INSPECTION REPORT
Sedimentation Structure
J16-D
Kayenta Mine
Navajo County, Arizona
for
PEABODY COAL COMPANY

Dames & Moore
10139-011-22

Plate 1

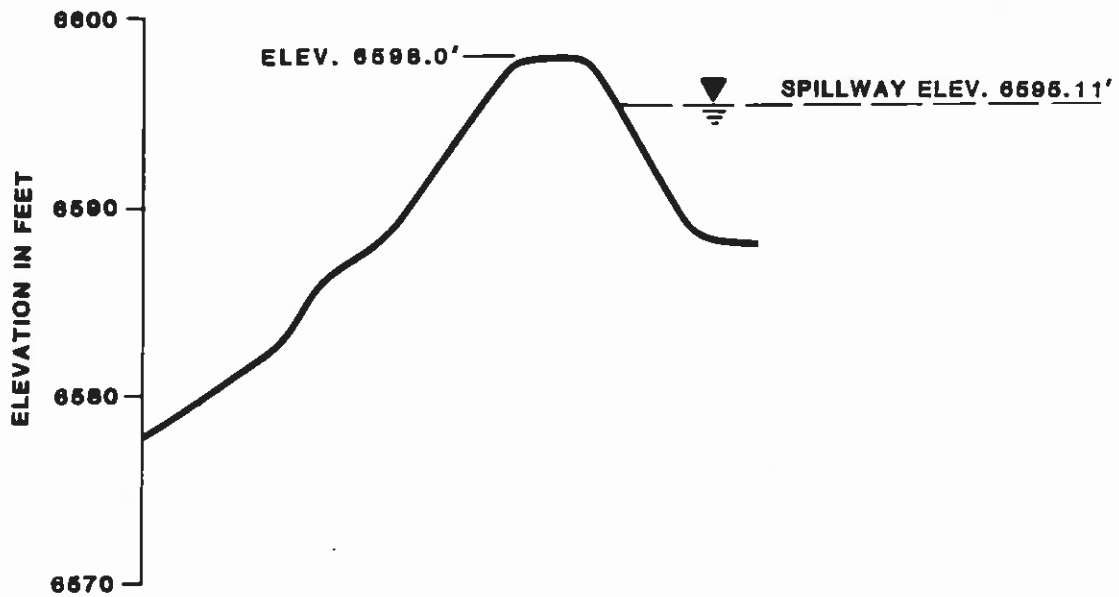
The spillway capacity of Structure J16-D is adequate but the storage capacity is inadequate. The storage capacity should be increased to 7.24 acre-feet by excavating the pond as shown on Plates 1 and 4. The trapezoidal outflow channel should be extended 20 feet along the alignment shown in Plate 1. The channel profile is shown in Plate 4 and the required dimensions are shown in Plate 5. Both the spillway and outflow channel extension should be protected against erosion using geotextile and riprap as shown in Plate 5.
